NL-19-001

April 15, 2019

Subject: License Amendment Request to Revise the Indian Point Energy Center Site
Emergency Plan to Address the Permanently Shut Down and Defueled
Condition

Indian Point Nuclear Generating Units 1, 2, and 3
Docket Nos. 50-003, 50-247, and 50-286
Facility Operating License No. DPR-5
Renewed Facility Operating License Nos. DPR-26, and DPR-64

Figure B-1.1 Indian Point Energy Center Station Watch Organization per Unit

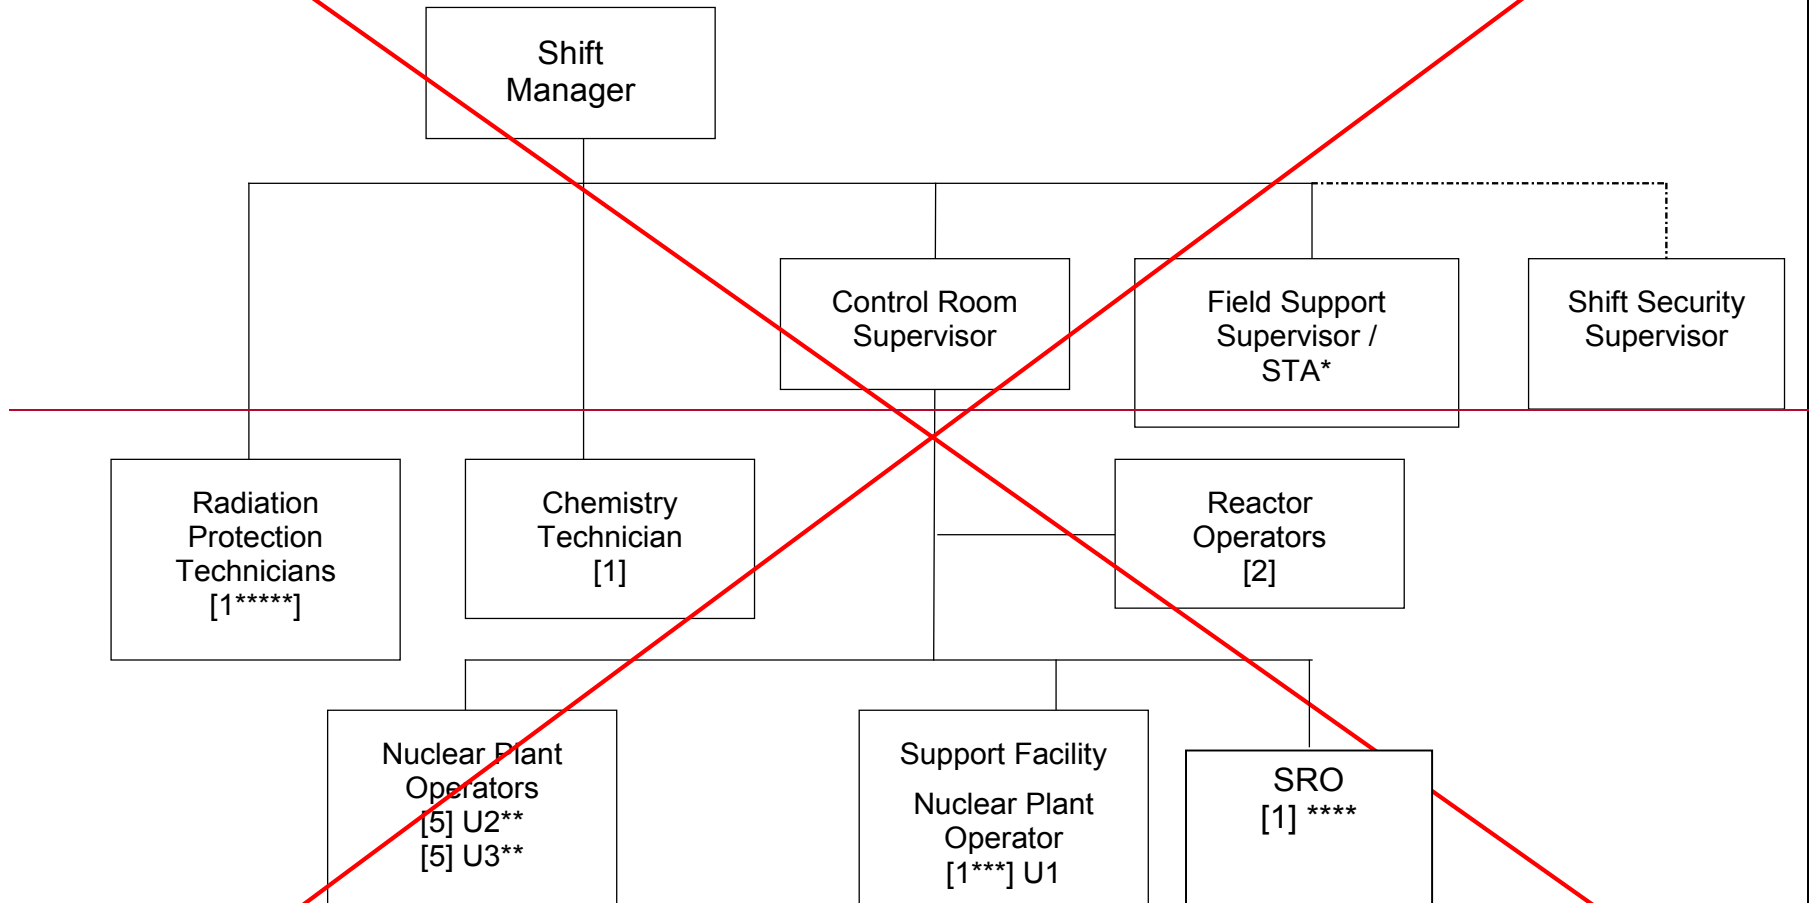
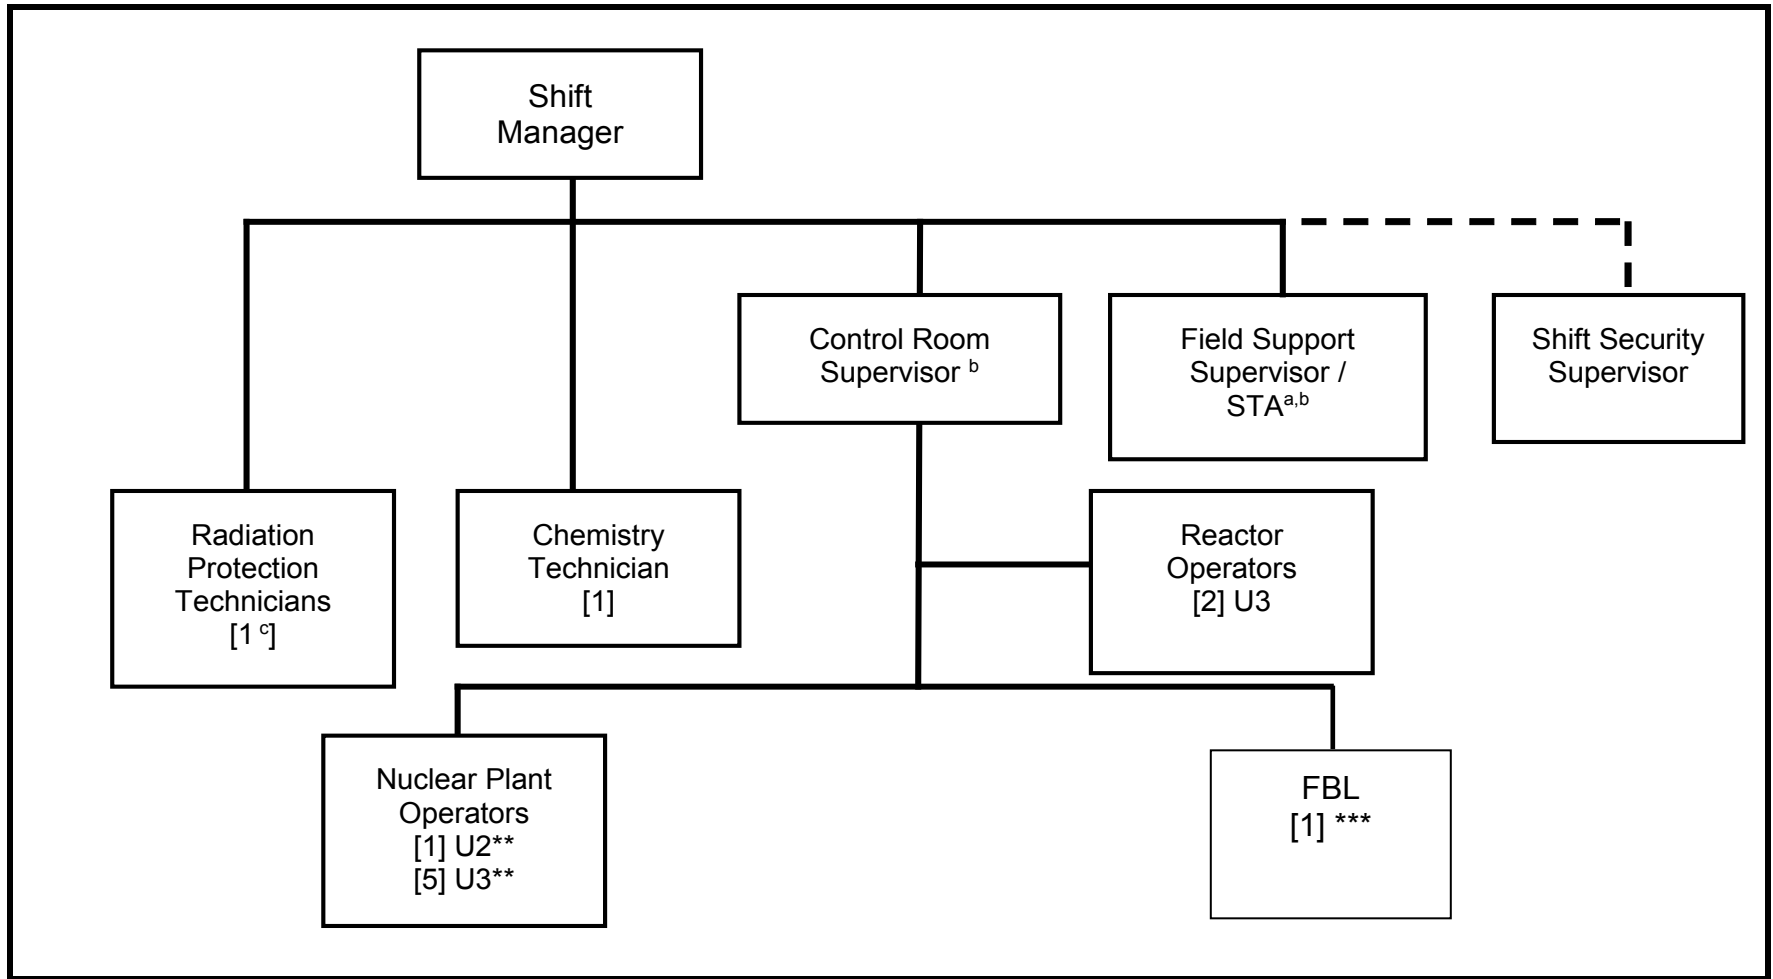
Emergency Plan Section	Before (Rev.19-01)	After (Rev. TBD)	Reason for Change
Part 2, Figure B-1.1	<i>Figure B-1.1, "Indian Point Energy Center Station Watch Organization per Unit" in Rev. 19-01 describes the normal watch organization. But, it does not distinguish between Units 2 and 3 for the majority of watch positions.</i>	For clarity between the normal watch positions at Units 2 and 3 with Unit 2 permanently shutdown and defueled, Figure B-1.1 has been revised as follows: Remove the following Unit 2 on-shift positions: • Control Room Supervisor • Field Support Supervisor/STA • Reactor Operators (2) • Nuclear Plant Operators (4) • Unit 1 Nuclear Plant Operator Added the following note: b. A Control Room Supervisor and STA will not be assigned to Unit 2 in the permanently shut down and defueled condition. Changed note ***** to note c. This RP Technician would assist at affected unit if needed. Changed note ***** to note *** One qualified individual would serve as FBL for both Units in accordance with Fire Protection Program Plan. Deleted the following note: *** Unit 2 has additional NPO who maintains watch on Unit 1 systems	Figure B-1.1 revised to reflect differing minimum required on-shift operating staff between Units 2 and 3 following permanent cessation of Unit 2 power operations and permanent removal of fuel from the reactor vessel.

~~Figure B-1.1 Indian Point Energy Center Station Watch Organization per Unit~~

~~*Consistent with NUREG-0737 and Technical Specifications, the Field Support Supervisor / Shift Technical Advisor is not required on shift during cold shutdown conditions.~~

~~***** This RP Technician would assist at affected unit if needed~~

Figure B-1.1 Indian Point Energy Center Station Watch Organization per Unit

^a Consistent with NUREG-0737 and Technical Specifications, the Field Support Supervisor / Shift Technical Advisor is not required on shift during cold shutdown conditions.

*** One qualified individual would serve as FBL for both units in accordance with the Fire Protection Program Plan
